Evaluation of proposed move for Water Right No. 27065

Proposed: Move water right no. 27065 ID2 a distance of 475 ft to the northeast.

WELL TEST ANALYSIS

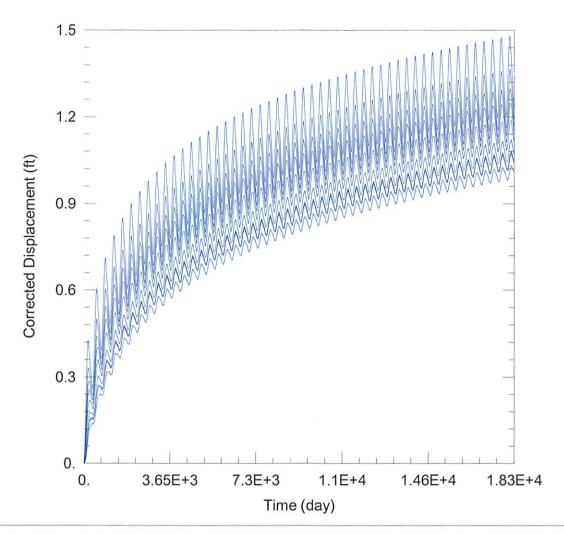
The saturated thickness at the proposed well location is estimated to be 106 ft, based upon the GMD3 model. For saturated thickness between 100 ft and 125 ft, the drawdown allowance is 2.5 ft.

50 year Theis Analysis: The following values were used to run the analysis:

S = 0.2419, T = 6759.3 ft²/day, $tp_{current} = 147$ days (based on average use and reported rate), $Q_{current} = 300$ gpm (last reported rate), $tp_{proposed} = 67$ days, $tp_{proposed} = 875$ gpm

Theis drawdowns were calculated as follows:

27065 ID1:

Drawdown from current location = 1.48 ft

Drawdown from proposed location = 2.30 ft

Net drawdown = 0.8 ft

Net drawdown does not exceed the drawdown allowance of 2.5 ft for any well within 1 mile of the proposed location. Therefore, critical well analysis is not necessary.

Conclusion:

The proposed move is likely to create minimal effects on neighboring wells and is unlikely to cause impairment. GMD3 staff recommends approval of this proposal.
